RESPONSE TO REQUEST FOR ADDITIONAL INFORMATION

APR1400 Design Certification

Docket No. 52-046

RAI No.: 306-8240
SRP Section: 06.02.06 - Containment Leakage Testing
Application Section: 6.2.6
Date of RAI Issue: 11/16/2015

Figure 6.2.4-1 Containment Isolation Valve Arrangement (11 of 13)

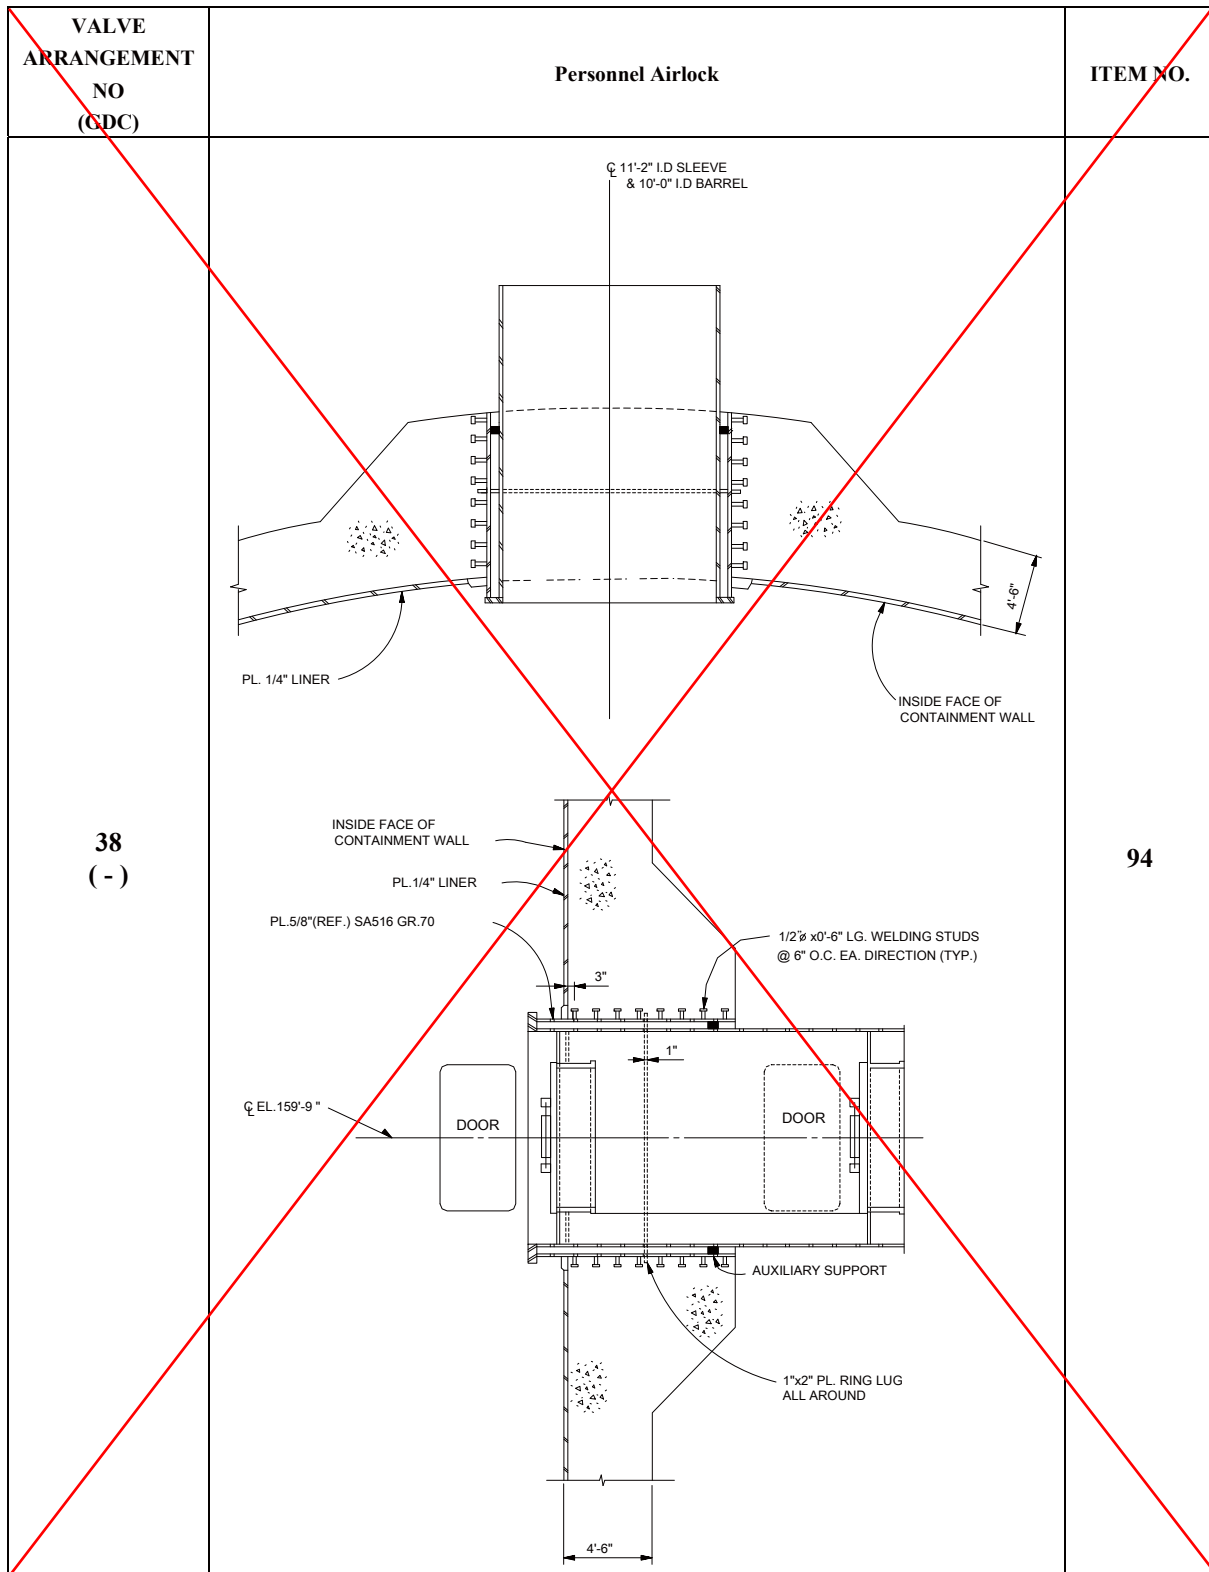
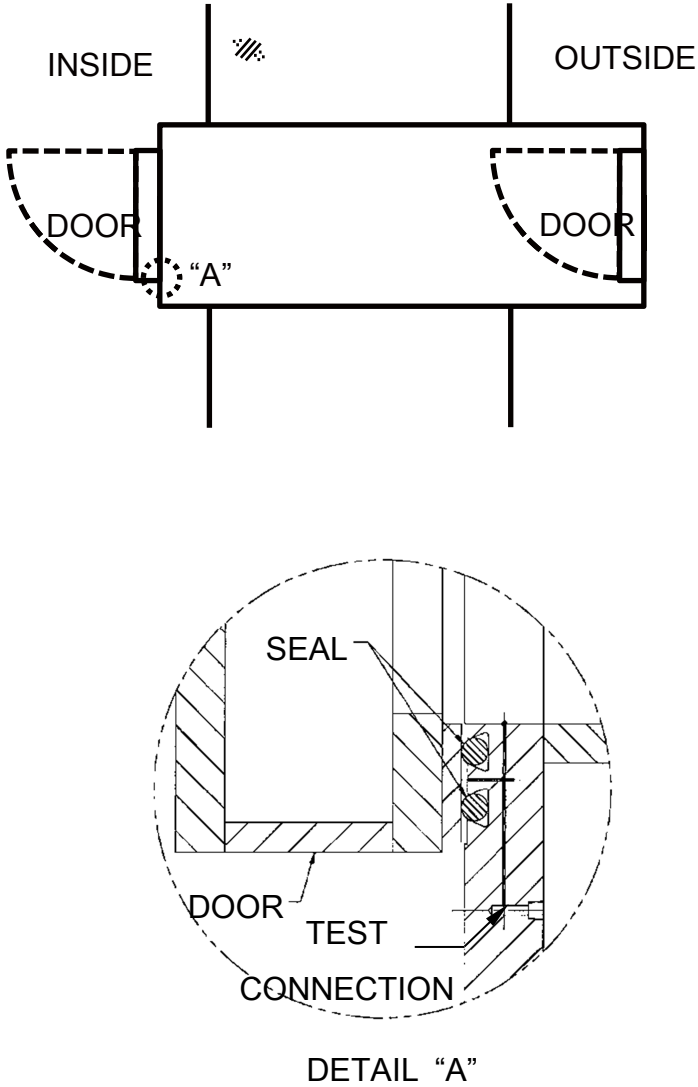
DCD Tier 2, Section 6.2.6.2 briefly discusses the Appendix J, Option B, Type B, leakage rate testing of containment penetrations and mentions Type B tests of personnel airlocks, the equipment hatch, fuel transfer tube flange and electrical penetrations. DCD Tier 2, Figure 6.2.4-1 Sheets 11 and 12 show the airlock and equipment hatch. However, they do not show any leak test connections or the seal arrangements. Please provide this information in the DCD.

DCD Tier 2, Figure 6.2.4-1 Sheets 11 and 12 will be revised to show the leak test connections in the personnel airlock and equipment hatch, respectively.
